DEVELOPMENT REVIEW BOARD REPORT

CASE NUMBER/ 29-DR-2005
PROJECT NAME Rancho Reata

REQUEST Request approval of a site plan and elevations for a mixed-use development.

Stipulations for Case: Rancho Reata Case 29-DR-2005

ATTACHMENT #4

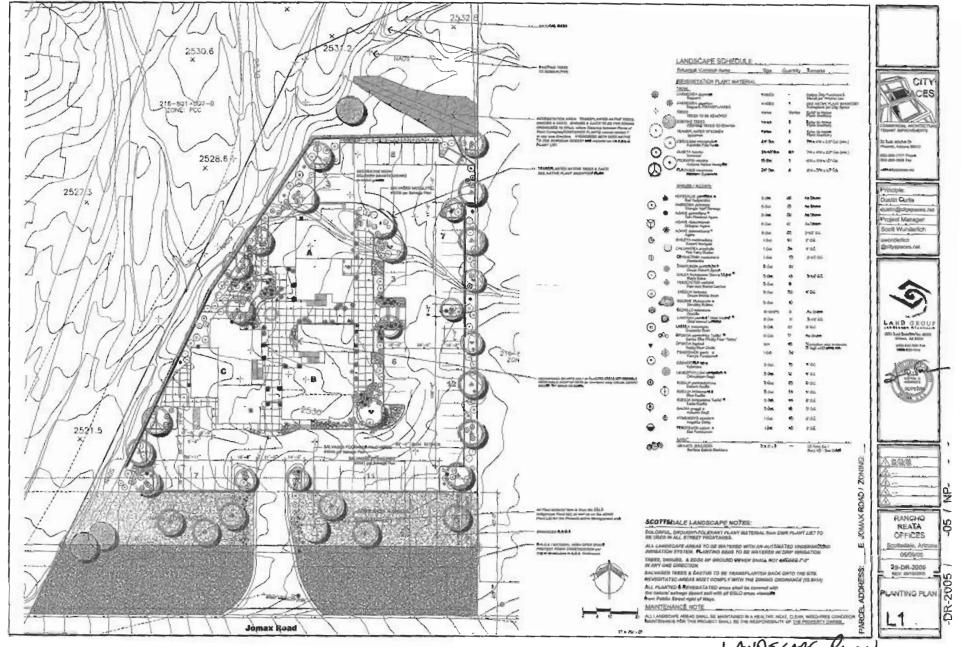
- 10. Applicant shall provide an accessible route from the ADA parking spaces to all building entrances.
- 11. Site plan shall be revised to list all development standards required/allowed and provided with all calculations shown.
- 12. Prior to final plans approval the applicant shall have received approval for a Land Division for Parcel A.

- B. Applicant shall obtain approval for the proposed water feature from City of Scottsdale Water Conservation Department prior to final plans submittal.
- C. Signs require separate approval and permit.
- D. Site plan shall be revised to dimension all parking spaces to meet the minimum 18 feet or 16 feet with a 2-foot overhang.
